UN Regulation No. 73 (Lateral Protection Devices)

Proposal for the 02 Series of Amendments to UN Regulation No. 73 (Lateral Protection Devices)

Submitted by the expert from Japan *

Figure 1

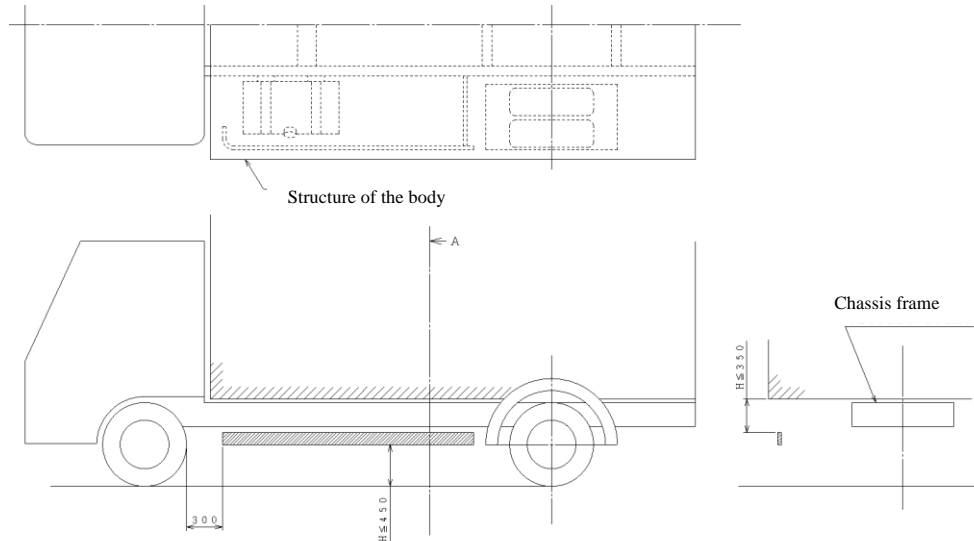
"12.9. The upper edge of LPD shall not be more than 350 mm below that part of the structure of the vehicle, cut or contacted by a vertical plane tangential to the outer surface of the tyres, excluding any bulging close to the ground (see **Figure 1 below**), except in the following cases:

"15.7. The upper edge of LPD shall not be more than 350 mm below that part of the structure of the vehicle, cut or contacted by a vertical plane tangential to the outer surface of the tyres, excluding any bulging close to the ground (see **Figure 1**), except in the following cases:

Figure 2

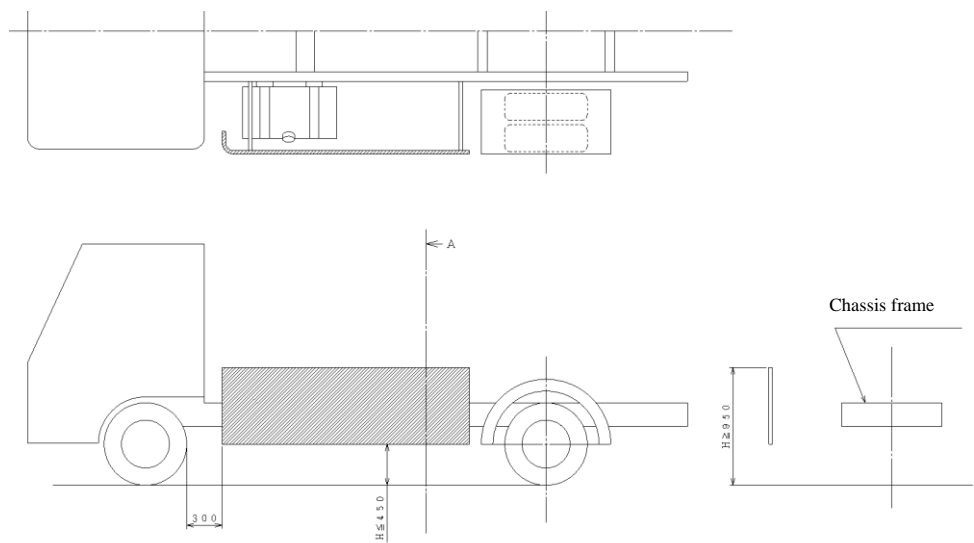
12.9.1. Where the plane in paragraph 12.9. does not cut the structure of the vehicle **or cuts the structure of the vehicle at a level more than 1.3 m above the ground, then the upper edge shall not be less than, then the upper edge shall be level with the surface of the load carrying platform, or 950 mm above the ground** (see **Figure 2 below**);

15.7.1. Where the plane in paragraph 15.7. does not cut the structure of the vehicle **or cuts the structure of the vehicle at a level more than 1.3 m above the ground, then the upper edge shall not be less than, then the upper edge shall be level with the surface of the load-carrying platform, or** 950 mm above the ground (see **Figure 2**);

Figure 3

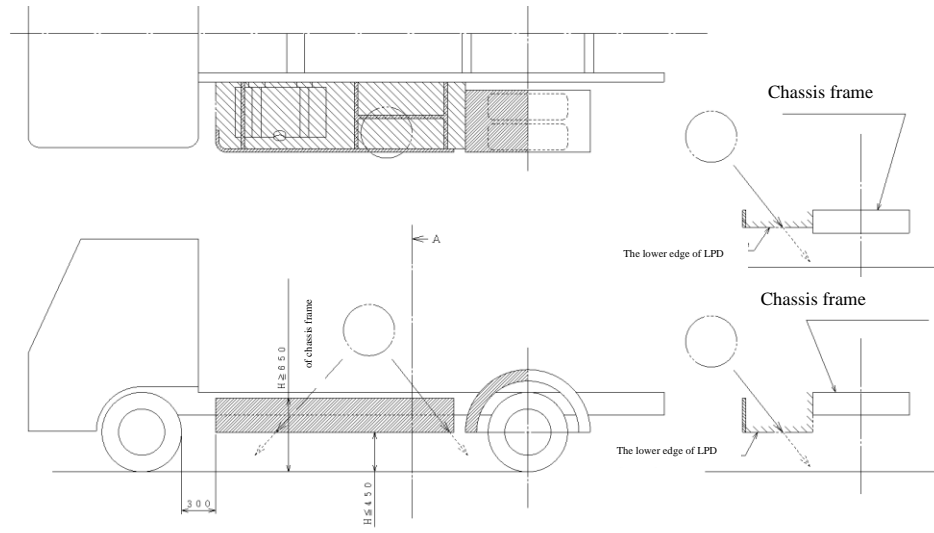
The upper edge of LPD is [650] mm above the ground, be level with the surface of the chassis frame, whichever is less, and the structure is designed to prevent cyclists from falling under the vehicle fly over the LPD (see Figure 2 below).

The fall prevention shall be demonstrated by the structure not allowing the [450] mm sphere to fall to the ground from the area enclosed by the LPD, chassis frame, and fender.

Other methods may be adopted to comply with this requirement if a manufacturer so requests. The sufficiency of the fall prevention method shall be established to the satisfaction of the Technical Service.

The upper edge of LPD is [650] mm above the ground, be level with the surface of the chassis frame, whichever is less, and the structure is designed to prevent cyclists from falling under the vehicle fly over the LPD (see Figure 3).

The fall prevention shall be demonstrated by the structure not allowing the [450] mm sphere to fall to the ground from the area enclosed by the LPD, chassis frame, and fender.
